TITLE : HWA 6D, HWA 14D new pump

MODEL : HWA 6D, HWA 14D

DATE : 2022-11-23 **NUMBER :** SI 221123

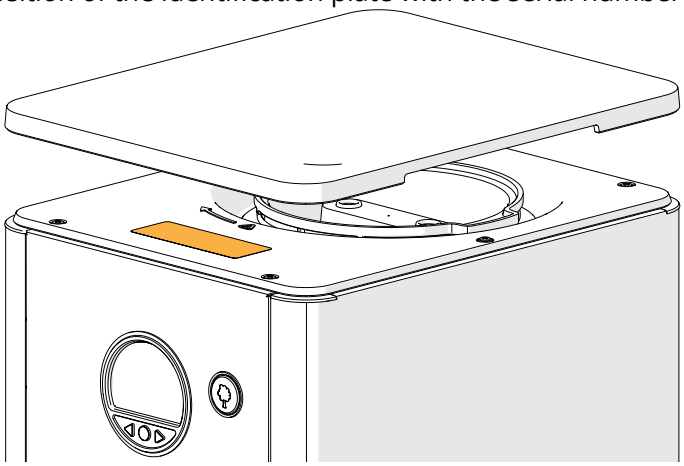
We have changed the pump of the HWA 6D and HWA 14D machines due to some issues with the pump.

Cause:
The old pump was in some cases causing extra noise and unintended error 9 messages.

Solution:
The new pump doesn't fit directly on earlier produced machines and because of this we have created a rebuild set of the new pump with some additional parts so that it can be used in earlier produced machines.

The first new pump (6,236,839,000) is used in machines starting with serial number ***020002346799***
